City of Burlingame

Meeting Minutes Planning Commission

- e. 1549 Los Montes Drive, zoned R-1 - Application for Design Review and Hillside Area Construction Permit for a new, two-story single family dwelling, and Special Permit and Front Setback Variance for an attached garage. (Erik Chan, Bay 9 Architects, applicant and architect; Thomas Lo, property owner) (136 noticed) Staff Contact: 'Amelia Kolokihakaufisi

Response to planning commission recommendations/comments

EXHIBIT A
NOT TO SCALE

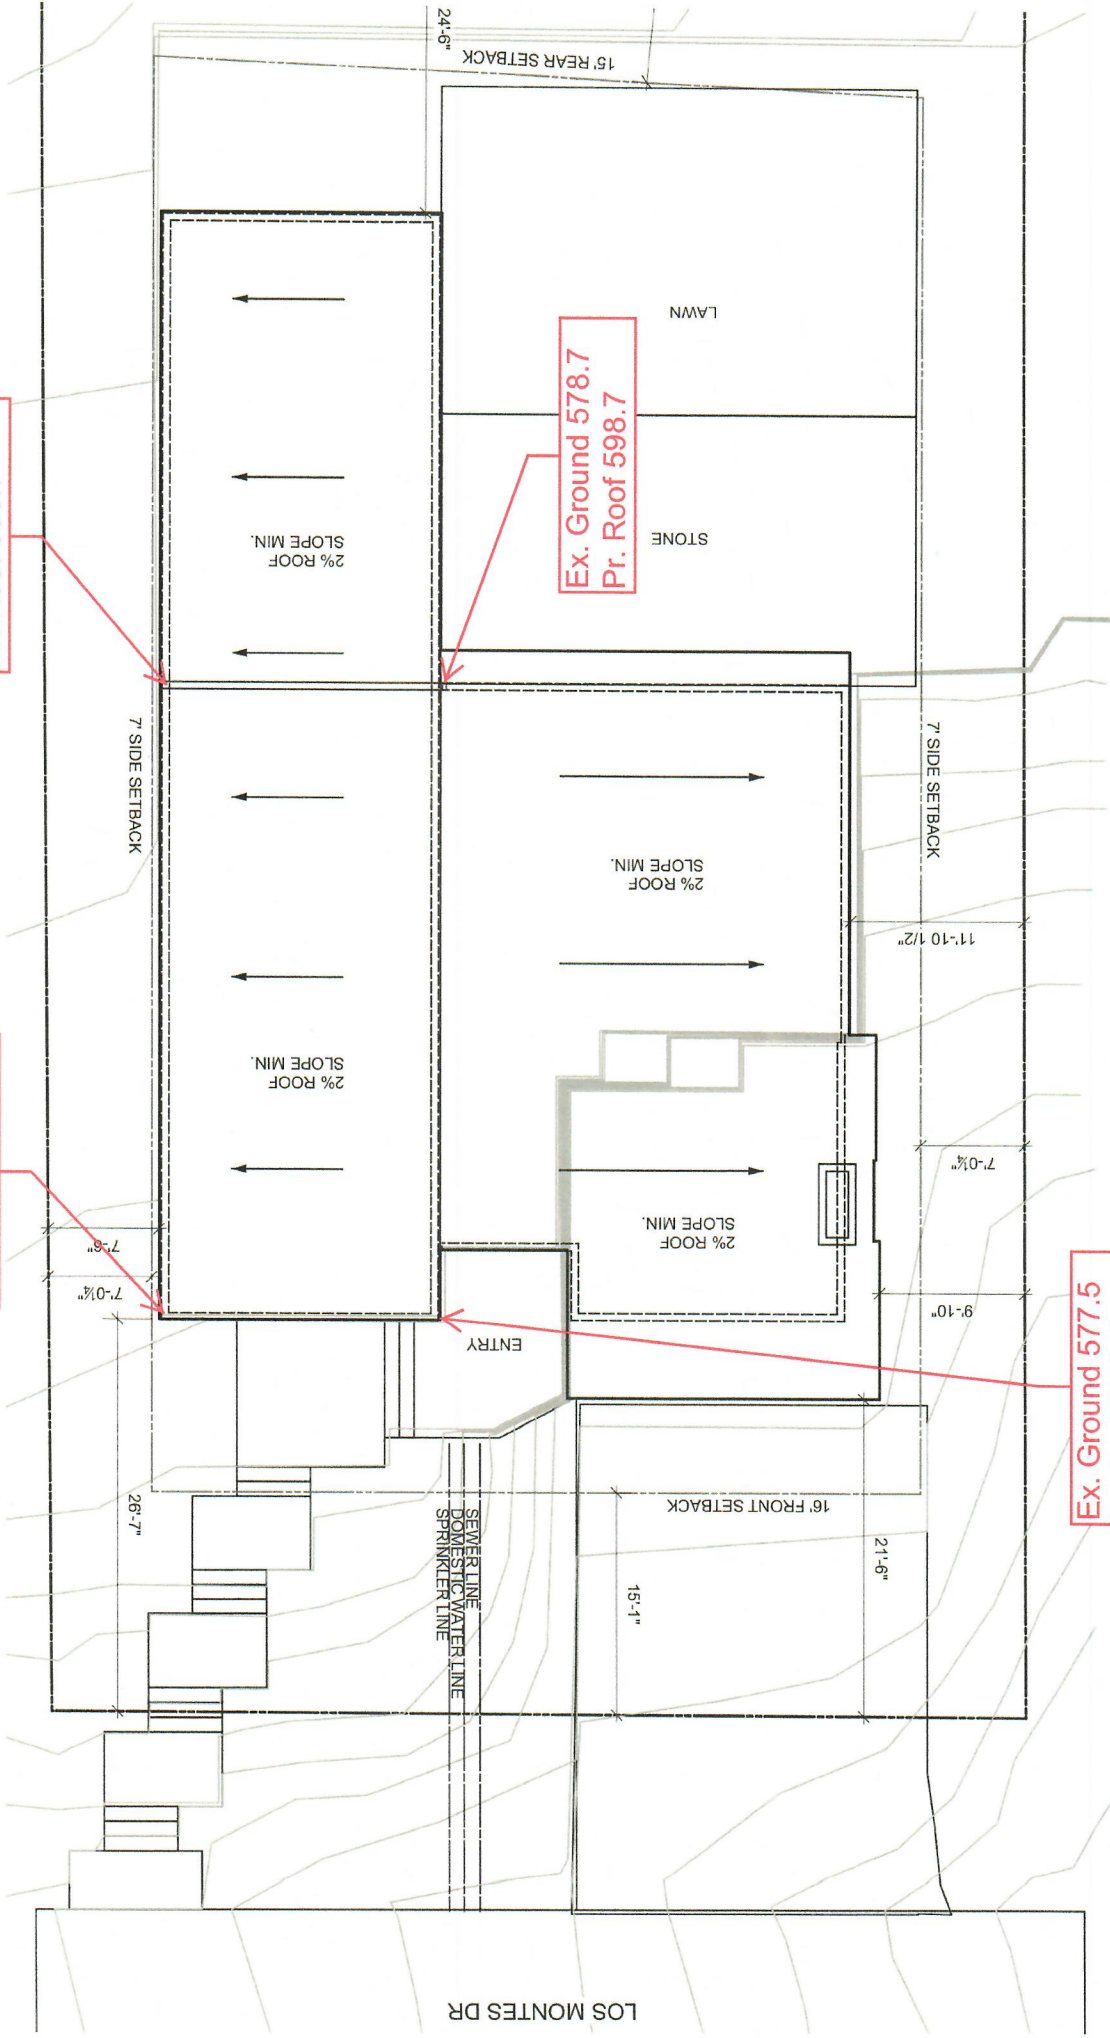
Story poles required

Story poles have been erected and certified by our licensed civil engineer, Cliff Bechtel

This is to certify that on 9/30/21 (date), the story poles located on the above-referenced site were installed or inspected by the undersigned, and found to be in conformance with the design, height, and location shown on the plans, elevations, and the attached story pole plan. Poles erected for second story element only.
